UNITED STATES PATENT AND TRADEMARK OFFICE

APPLICATION NO.	FILING DATE	FIRST NAMED INVENTOR	ATTORNEY DOCKET NO.	CONFIRMATION NO.
09/912,103	07/23/2001	Huong Thanh Nguyen	5619/DD/LOW K/JW	4476
32588	7590	02/22/2006	EXAMINER	
APPLIED MATERIALS, INC. 2881 SCOTT BLVD. M/S 2061 SANTA CLARA, CA 95050			NGUYEN, KHIEM D	
			ART UNIT	PAPER NUMBER
			2823

Office Action Summary

DETAILED ACTION***Response to Applicants' Amendment and Argument***

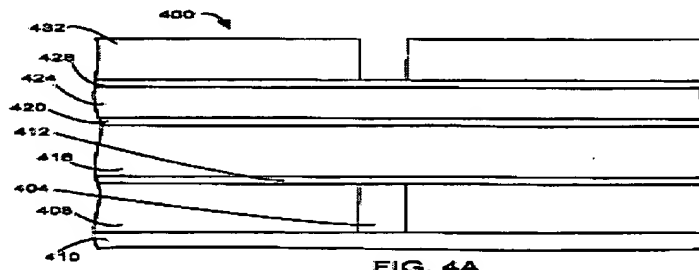
In re claim 1, Annapragada discloses a method of fabricating a damascene structure, comprising: (a) forming a barrier layer **412** on a substrate **410** having a metal layer **404** thereon; (b) forming a first organosilicate layer **416** on the barrier layer **412**;

(c) forming a silicon oxide layer 420 on the first organosilicate layer 416; (d) forming a second organosilicate layer 424 on the silicon oxide layer 420 (col. 2, line 46 to col. 3, line 21 and FIGS. 4A-B); and

FIG. 4B

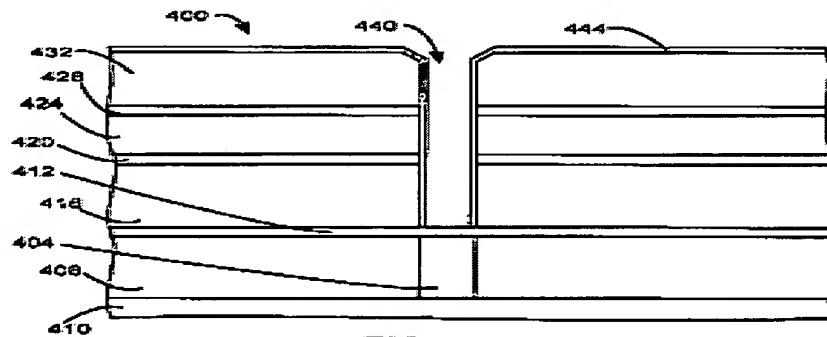
(e) etching the second organosilicate layer 424 to define vias 440 therein, wherein the second organosilicate layer 424 is etched with a gas mixture comprising a hydrogen-containing fluorocarbon and one or more gases selected from the group consisting of hydrogen (H₂), nitrogen (N₂), oxygen (O₂), argon (Ar), and helium (He) (col. 4, lines 9-67).

FIG. 4C

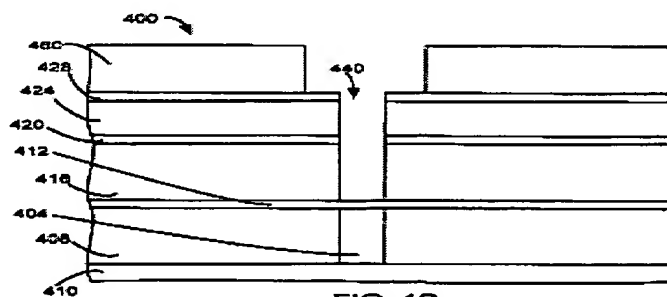
(f) etching the silicon oxide layer 420 to transfer the vias 440 defined in the second organosilicate layer 424 therethrough (FIG. 4C);

FIG. 4B

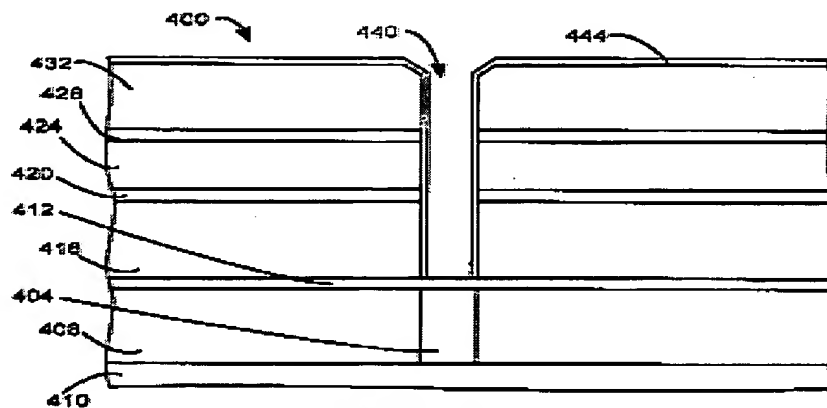
(c) forming a silicon oxide layer 420 on the first organosilicate layer 416; (d) forming a second organosilicate layer 424 on the silicon oxide layer 420 (col. 2, line 46 to col. 3, line 21 and FIGS. 4A-B); and

(e) etching the second organosilicate layer 424 to define vias 440 therein, wherein the second organosilicate layer 424 is etched with a gas mixture comprising one or more hydrogen-containing fluorocarbon gases and one or more gases selected from the group consisting of hydrogen (H_2), nitrogen (N_2), oxygen (O_2), argon (Ar), and helium (He) (col. 4, lines 9-23); and

(f) etching the silicon oxide layer 420 to transfer the vias 440 defined in the second organosilicate layer 424 therethrough, wherein the silicon oxide 420 is etched with a gas mixture comprising a fluorocarbon gas (col. 9, lines 9-23);
